SEWAGE DISPOSAL SYSTEM

DEPARTMENT OF HEALTH AND MENTAL HYGIENE

A REPAIR

SUBDIVISION Trotter Hills LOT 1 ROAD 5620 5640 Trotter Road

INDICATE NORTH - NAME ADJOINING ROADWAY AS BASE LINE
Trotter Road

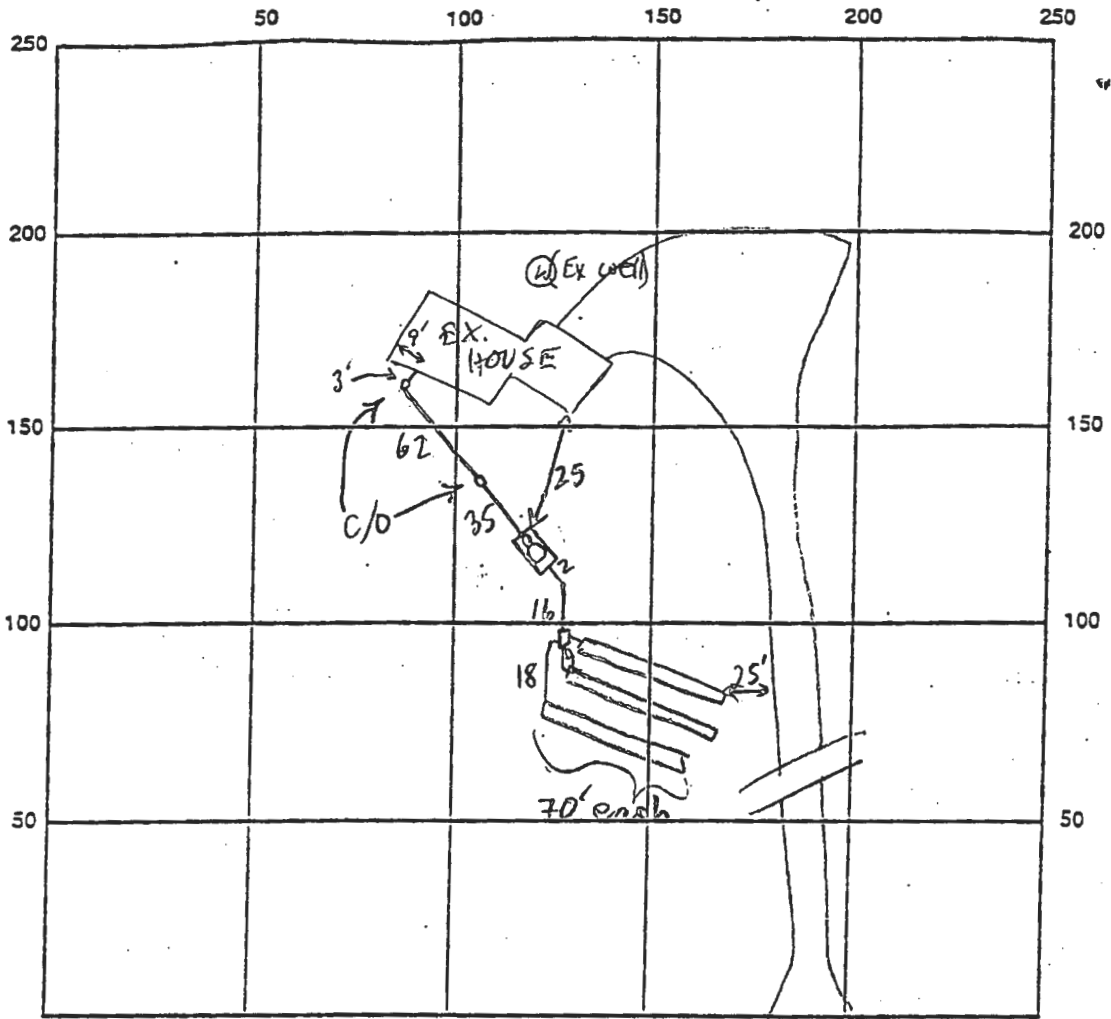
REMARKS: 3/26/99 layout check - no work done. DKS

3/29/99 septic tank to be moved (originally set 75 from well in error). DKS

ORIG. SEPTIC TO BE ABANDONED IN NEXT FEW DAYS

3/30/99 OK TO COVER ALL (MR)

3/31/99 Abandonment of ex septic tank and drywell
